THE FOLGER SHAKESPEARE LIBRARY

## U.S. Commission of Fine Arts Permit Review – Follow-up

16 April 2020

**PROPOSED DESIGN** VIEW FROM EAST CAPITOL STREET – REVISED  
 THE FOLGER SHAKESPEARE LIBRARY - U.S. COMMISSION OF FINE ARTS

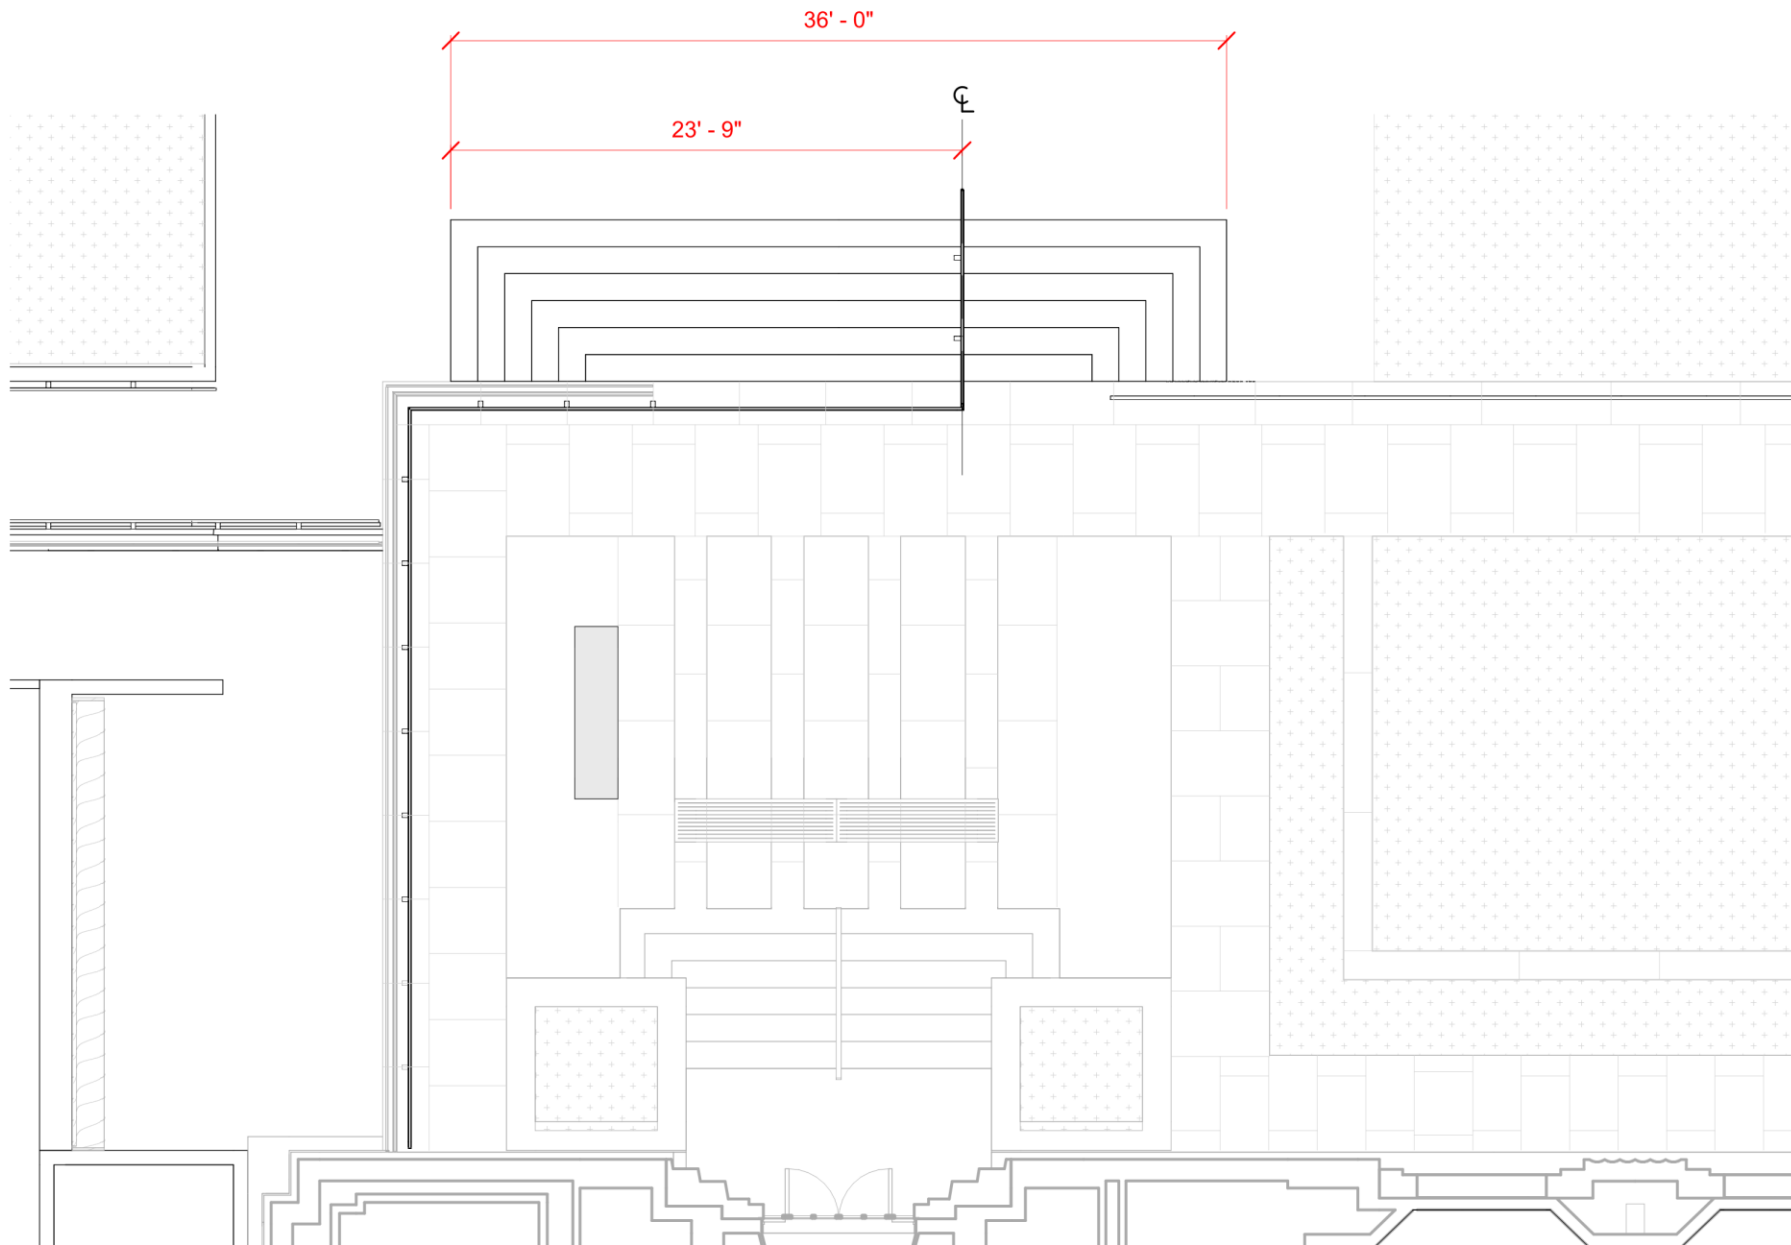
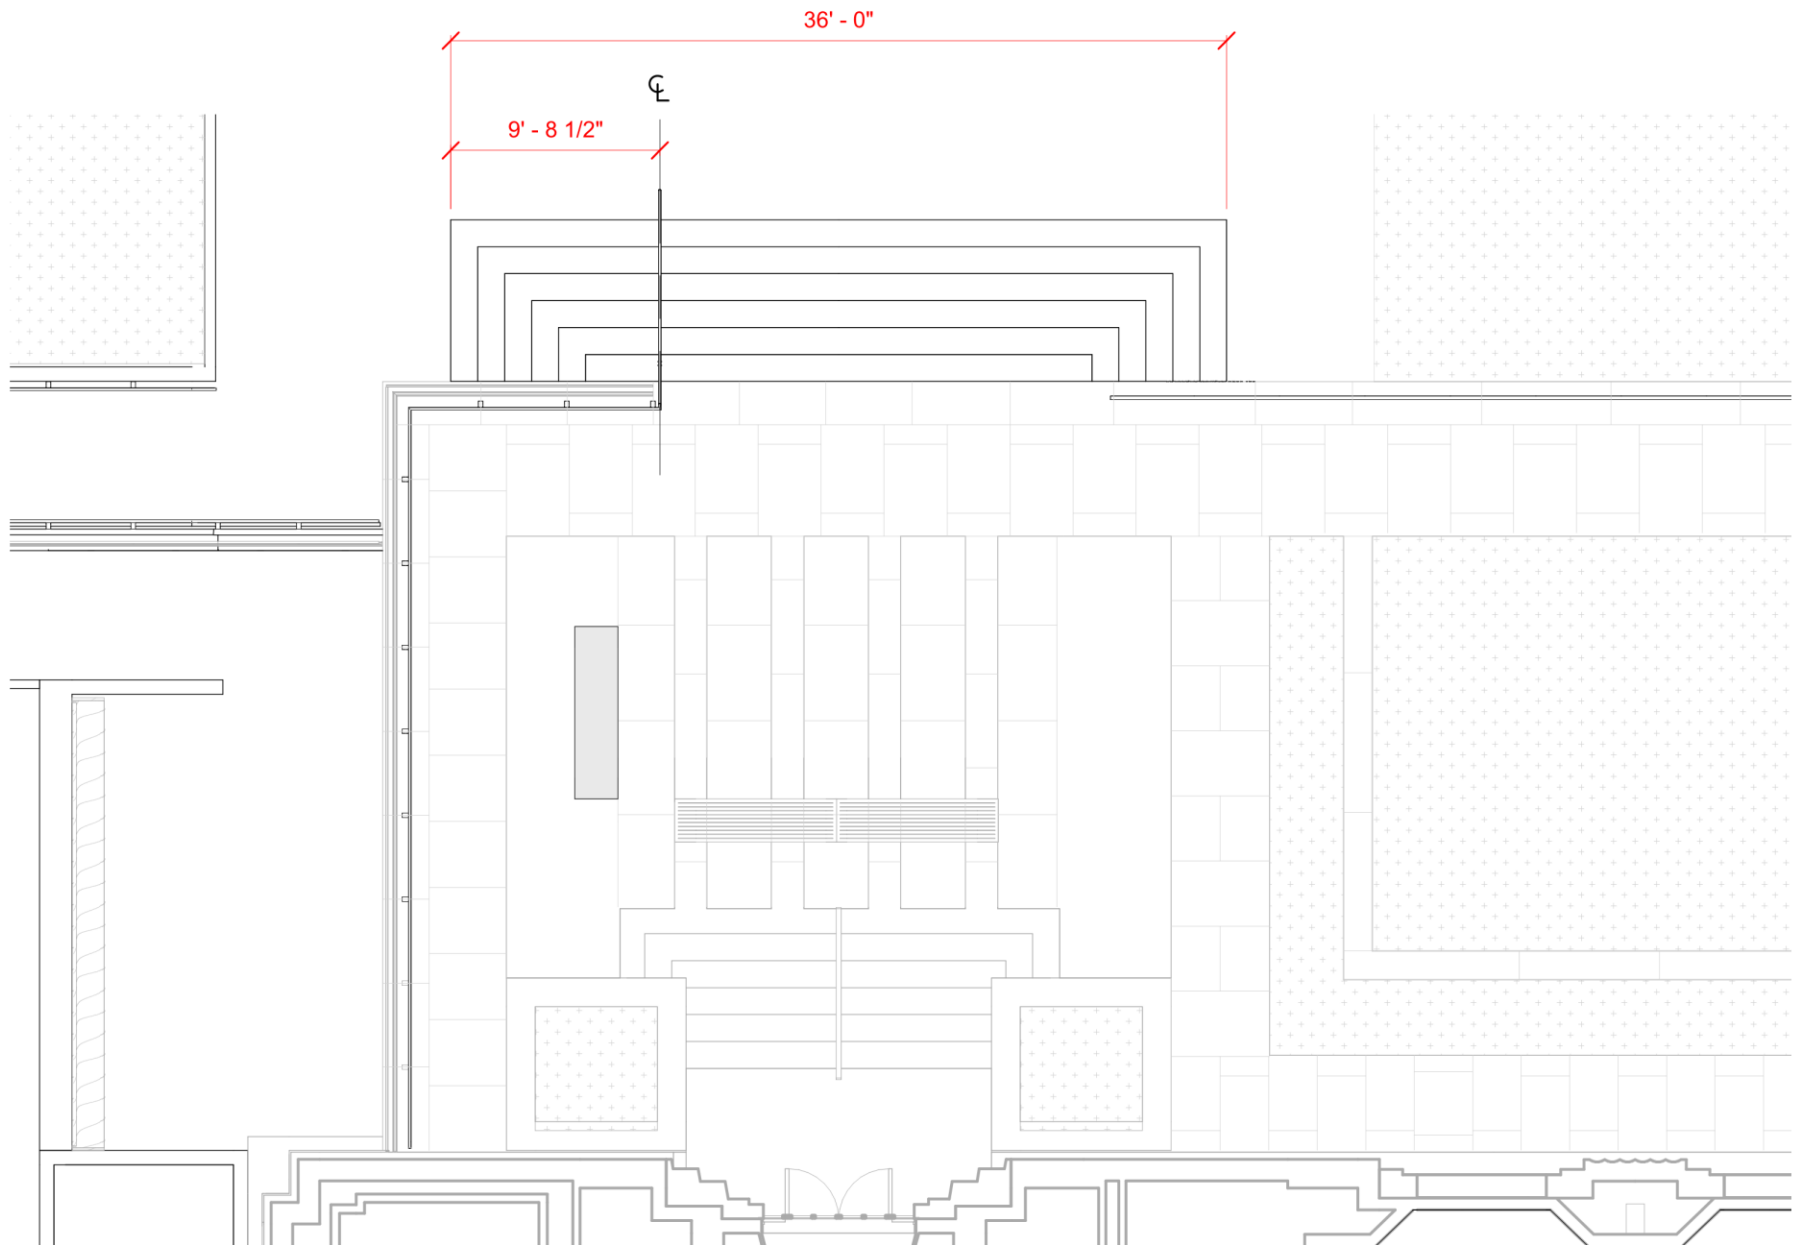
“...the Commission members recommended eliminating the segments of handrail that would extend across the top of the steps to each side of the terrace in order to minimize visible disruptions to frontal views of the Cret building.”

“They also recommended the elimination of two types of wayfinding signs at the front of the building: the railing-mounted signs reading “entrance” at the terrace stairway, and the small monument signs adjacent to the sidewalk.”

## TYPEFACE

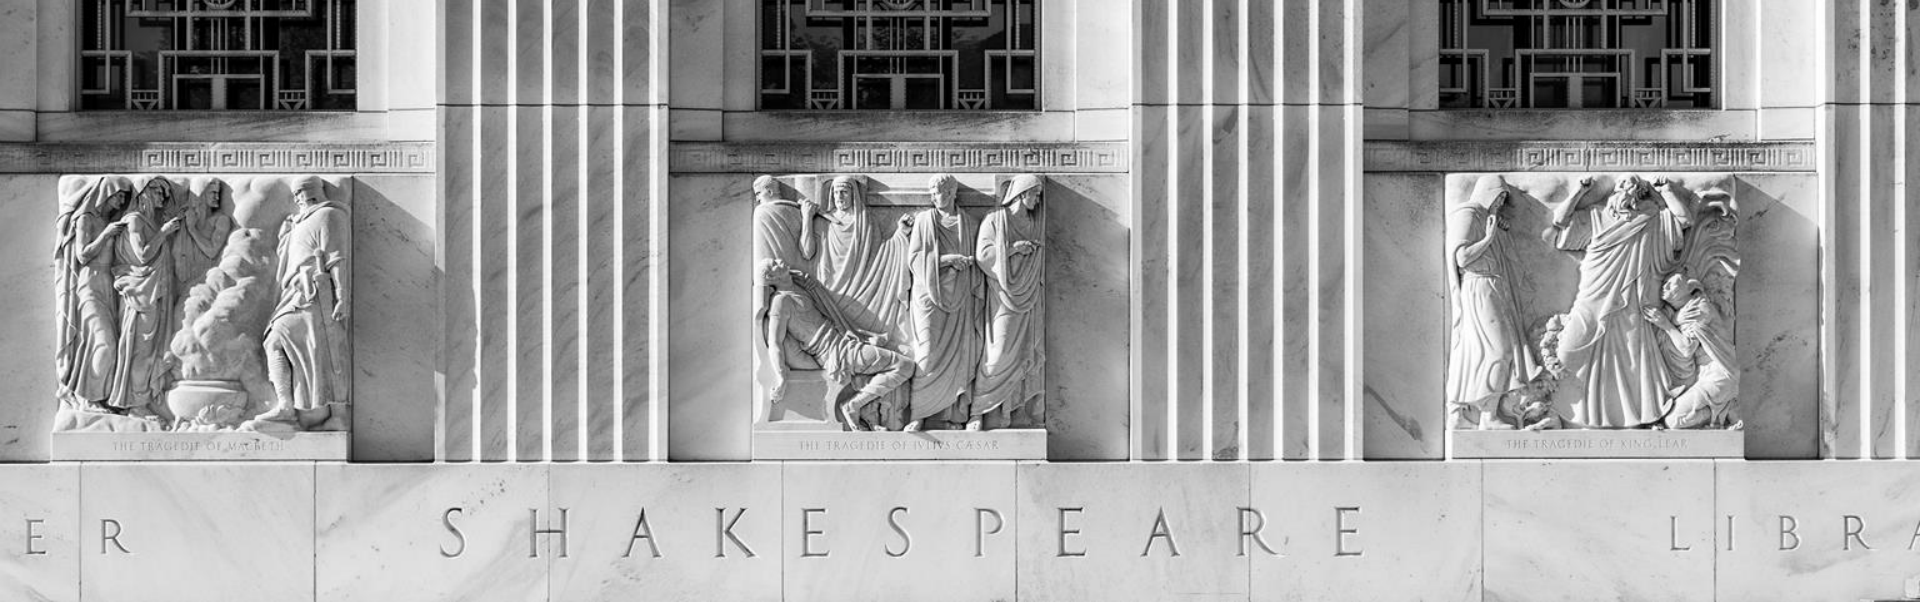
“For the design of the signs, they recommended simplification of the range of typography selected for the various proposed types of text, with a single sans-serif typeface used for wayfinding and serif typefaces used for the honorific identity signs and the quotations.”

**SIGNAGE AND WAYFINDING** PROMOTIONAL TOTEM – AS PRESENTED ON FEBRUARY 20  
THE FOLGER SHAKESPEARE LIBRARY

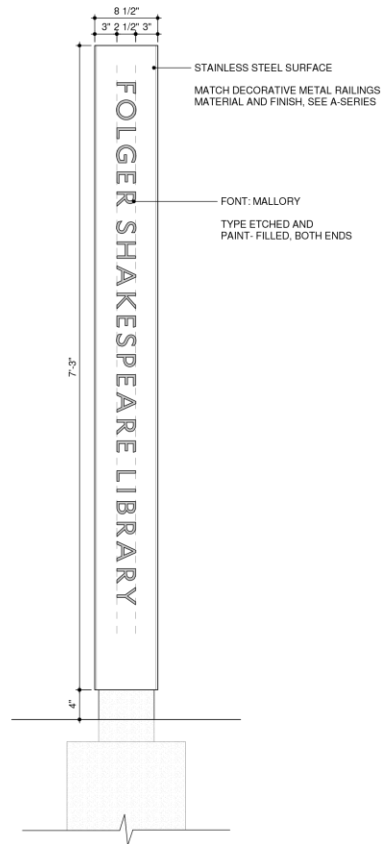
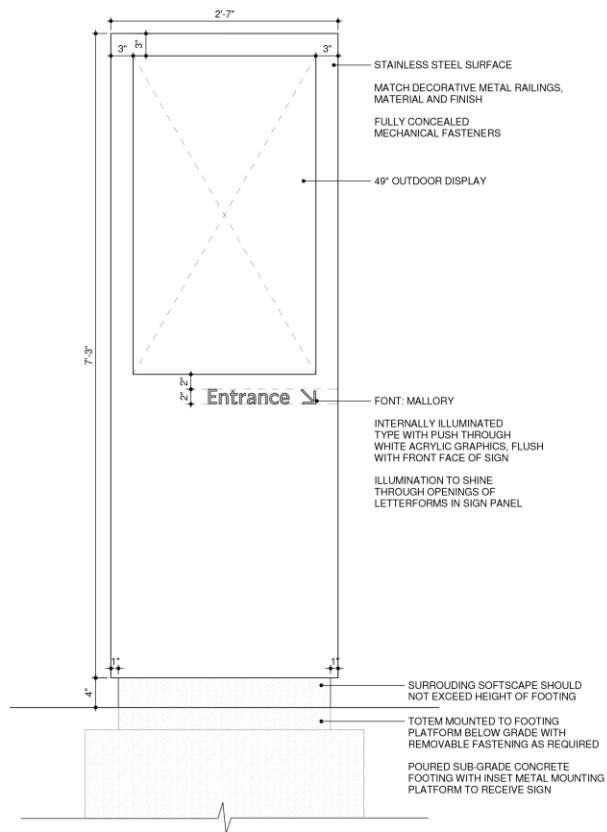
“They also recommended reducing the number of materials used on the proposed pylon signs at the east and west entrances in order to avoid using marble merely as a minor accent.”

**NORTHEAST CORNER**

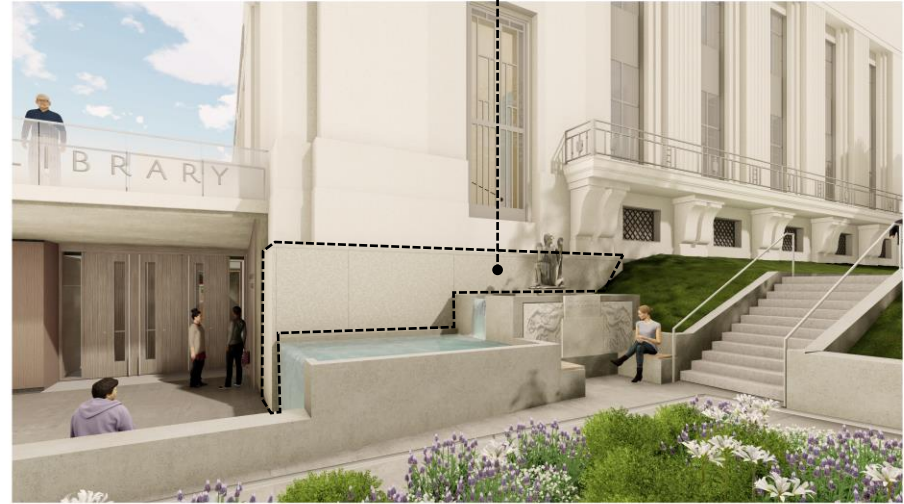
“The Commission members expressed concern about the materials and design of the northeast and northwest corners of the historic Cret building that would be exposed at the new excavated entrance plazas. They questioned the choice of concrete as the finish material for the base of the marble building volume, a treatment that they found could appear like exposed underpinning; they suggested consideration of a stone such as granite, which would equally well differentiate the new construction from the original but would be a more noble material commensurate with the character of the historic building. “

MOUNT AIRY  
GRANITE

MOUNT AIRY  
GRANITE

**NORTHEAST CORNER**— REVISED ELEVATIONS AND PLAN  
THE FOLGER SHAKESPEARE LIBRARY - U.S. COMMISSION OF FINE ARTS

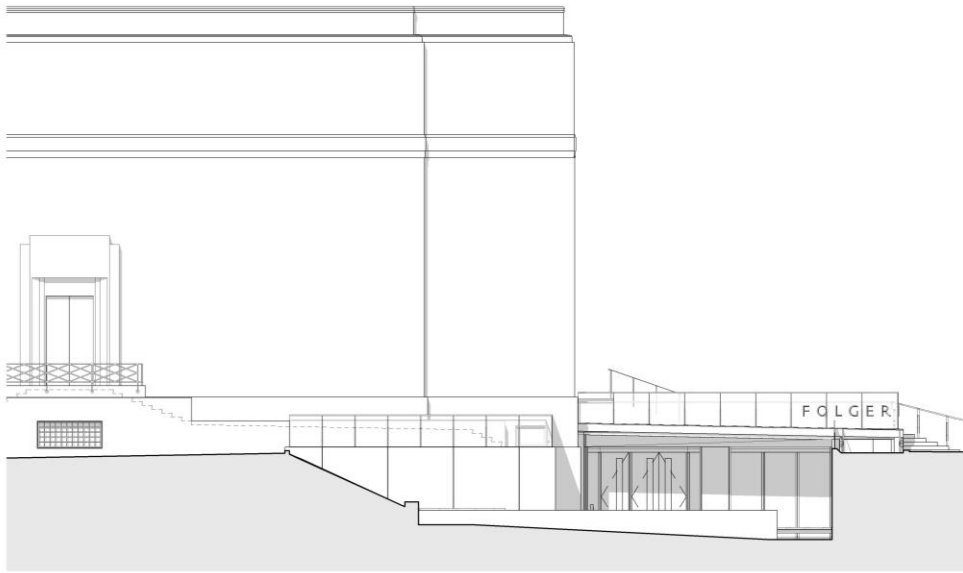
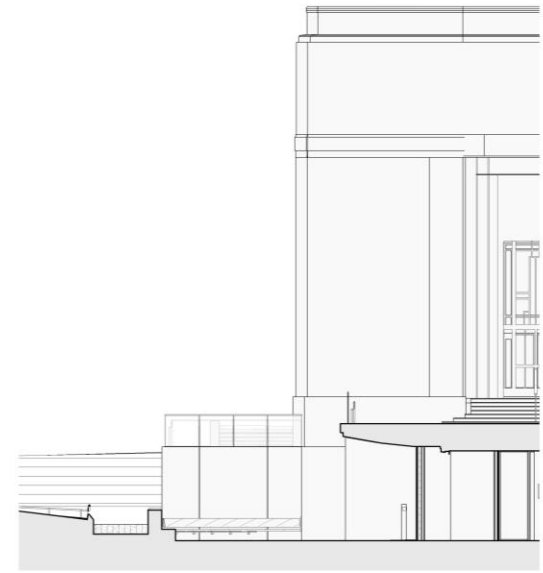
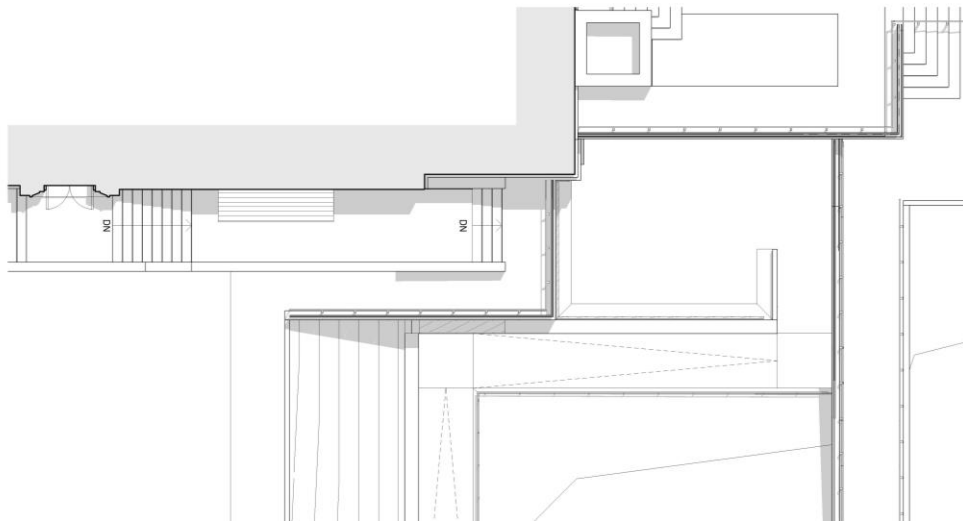
“They also recommended that the "Juliet" balcony at the northeastern corner be less massive in appearance, redesigned with a more consistent relationship to the datum that separates the Cret building's principal storeys from the new, exposed basement walls, as seen in the base treatment at the northwestern corner.”

## MATERIALS

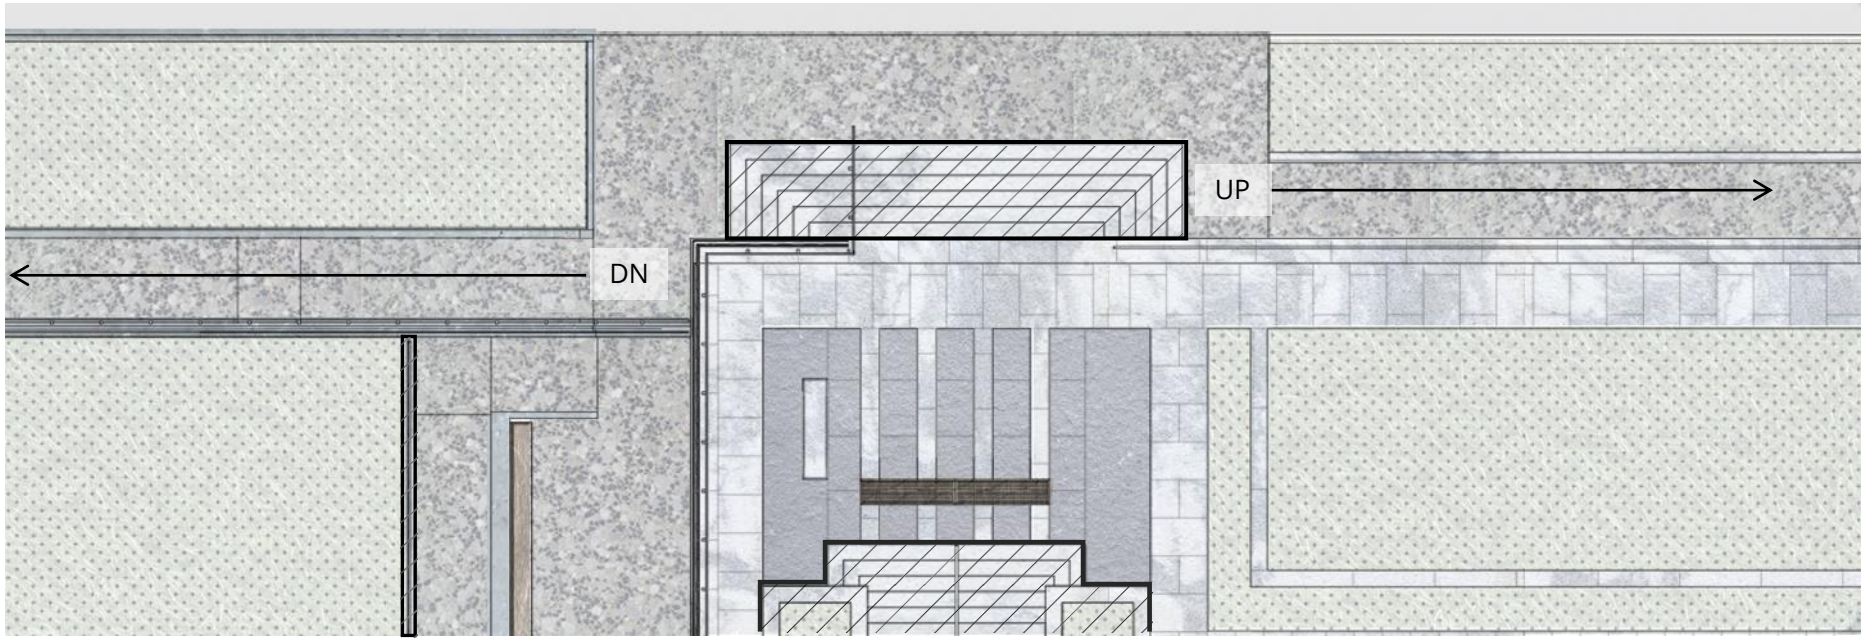
“In general, they requested a full presentation of proposed samples for all exterior materials, large enough to convey their character and accompanied by detailed drawings if necessary, commenting that they were not able to complete their review of the project without these samples.”
